**City of Portland, Maine - Building or Use Permit Application** 389 Congress Street, 04101, Tel: (207) 874-8703, FAX: 874-8716

**BUILDING PERMIT REPORT**

DATE: 25/MAY/99 ADDRESS: 36 Newton ST CBL: 337-C-054  
 REASON FOR PERMIT: Above ground pool & deck  
 BUILDING OWNER: Strum & Cecere  
 PERMIT APPLICANT: NANCO For Pool Contractor  
 USE GROUP 4 BOCA 1996 CONSTRUCTION TYPE \_\_\_\_\_

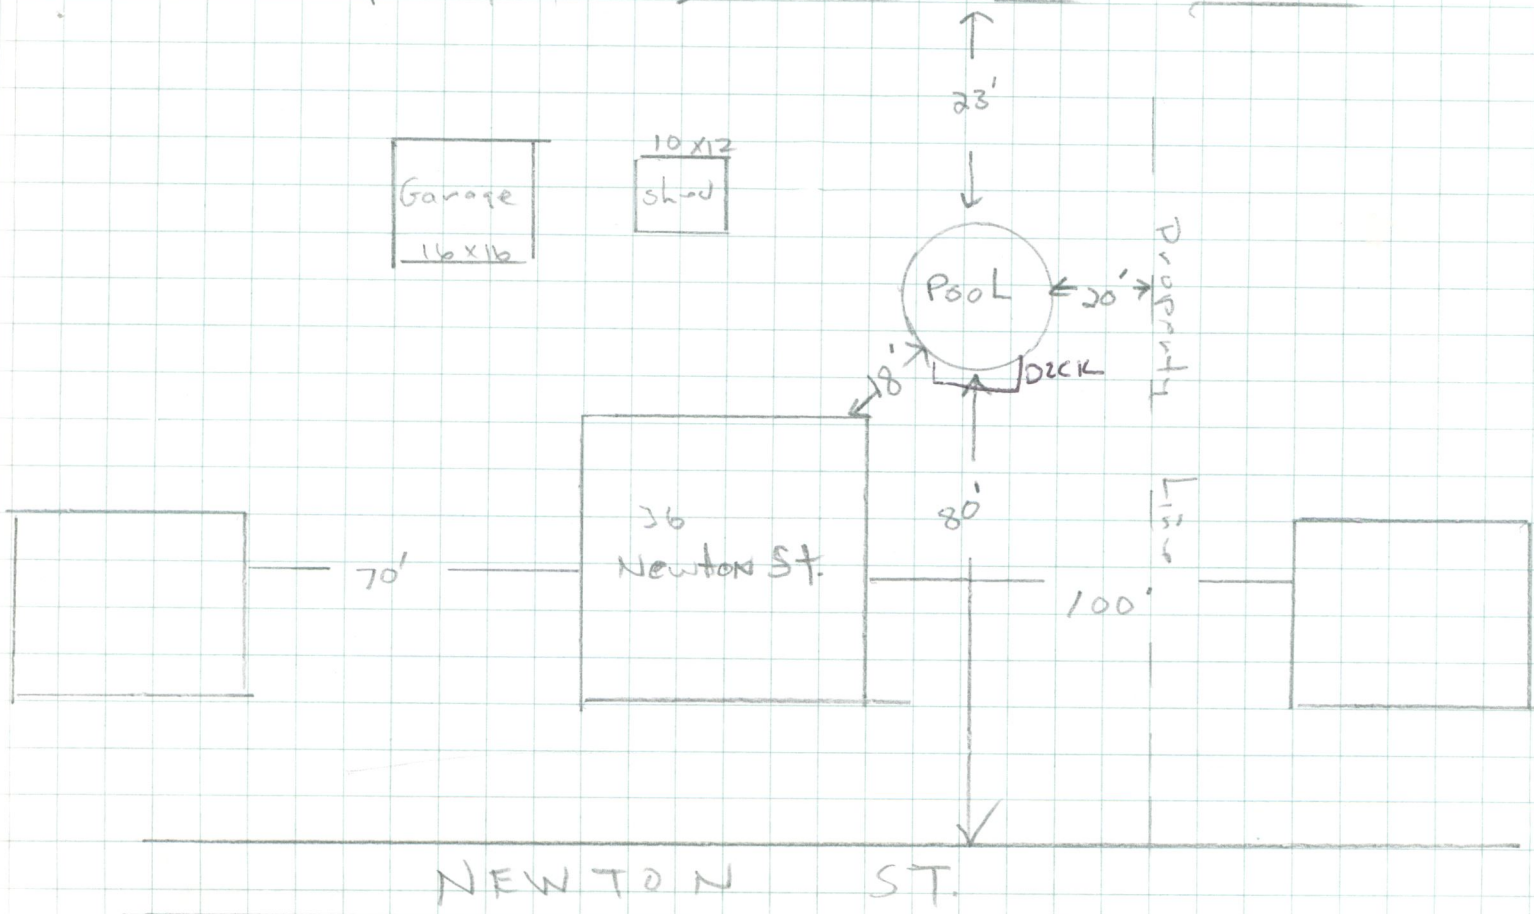
Needs 10'  
All the way around  
including the principal  
structure of  
5/24/99
